STAFF RECOMMENDATION
4100 Aberdeen Road
October 21, 2020

Application: New Construction—Infill
District: Cherokee Park Neighborhood Conservation Zoning Overlay
Council District: 24
Base Zoning: R8
Map and Parcel Number: 10308019200
Applicant: Van Pond, Architect
Project Lead: Sean Alexander, sean.alexander@nashville.gov

Description of Project: The proposal is to construct a one and-one-half story house with an attached garage, replacing a non-contributing one-story house. The new house will have brick walls on the first story and half-timbering and panel cladding on the upperstory gable fields.

2 CONTEXTUAL ELEVATIONS WITH NEW STRUCTURES- FACING NORTH

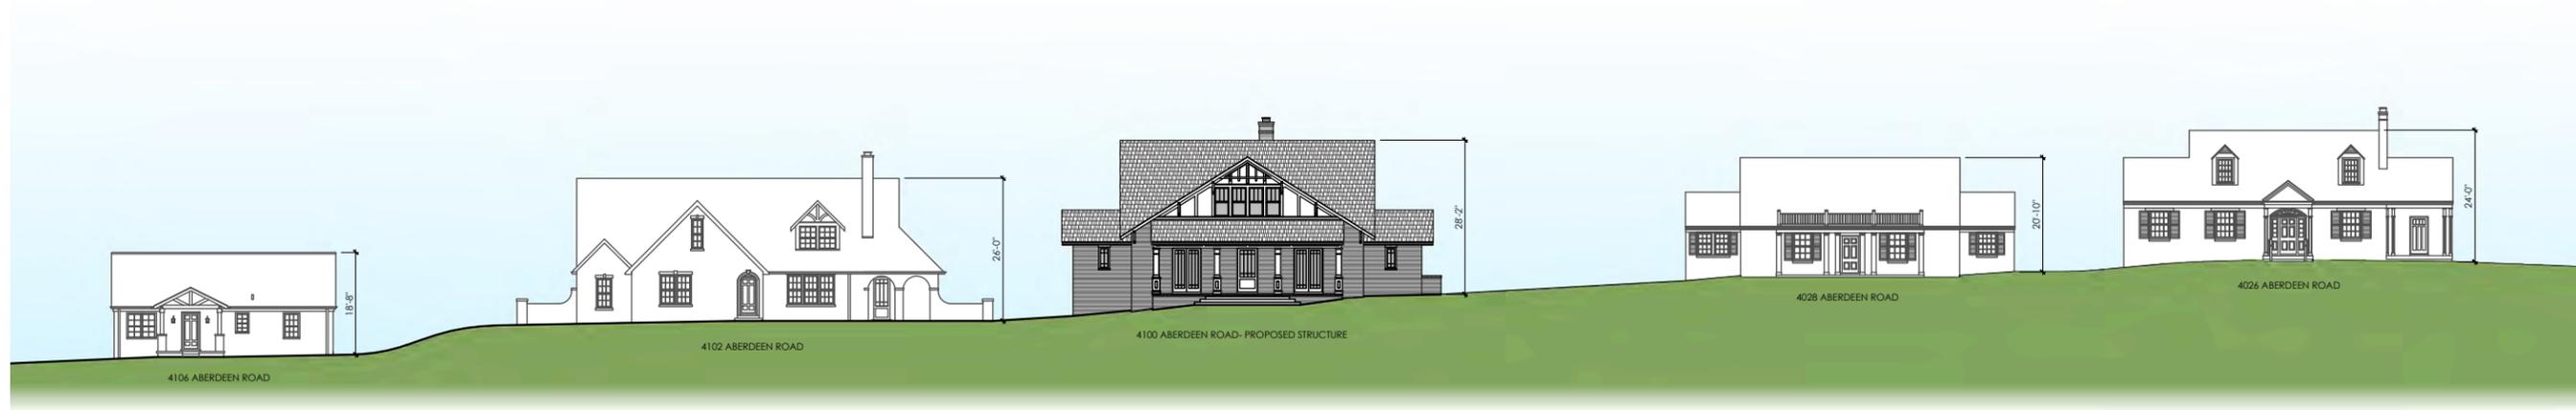
Height & Scale: The proposed infill will be one and one-half-stories with a roof-ridge height of twenty-seven feet, eight inches (27'-8") above the first floor level, and an eave height of nine feet, six inches (9'-6") above floor level. The adjacent houses to the left and right are twenty-seven feet (27') tall and twenty-two feet (22') tall, respectively. Although the proposed house is taller than its immediate neighbors, the difference is minimal, and the surrounding area does include several houses that are twenty-eight feet (28') tall or taller. The foundation will vary from four feet (4') tall on the left side of the house to less than one foot (1') tall on the right, due to a cross-slope on the lot down from right to left.

The proposed infill at 4100 Aberdeen Road will be sixty-three feet, nine inches (63'-9") wide in total which is wider than both adjacent houses. The house to the right is fifty-seven feet (57') wide and the house to the left, which is currently the widest house in the immediate vicinity, is sixty-one feet (61') wide. The houses to the right and left are also located on wider lots, one hundred feet (100') and one hundred, twenty feet (120') respectively, whereas this lot is eighty-five feet (85') wide. Staff finds that the width of the proposed building is not appropriate and recommends that the width shall be limited to fifty-six feet (56') to be compatible with the surrounding context on similarly sized lots.

1. The width of the house shall be reduced to fifty-six feet (56');
2. The foundation material shall be different from that of the primary wall material;
3. All materials shall receive final approval from staff prior to purchase and installation: foundation material, window and door selections, roof colors; driveway and walkway; and,
4. The HVAC units shall be behind the midpoint of the building.
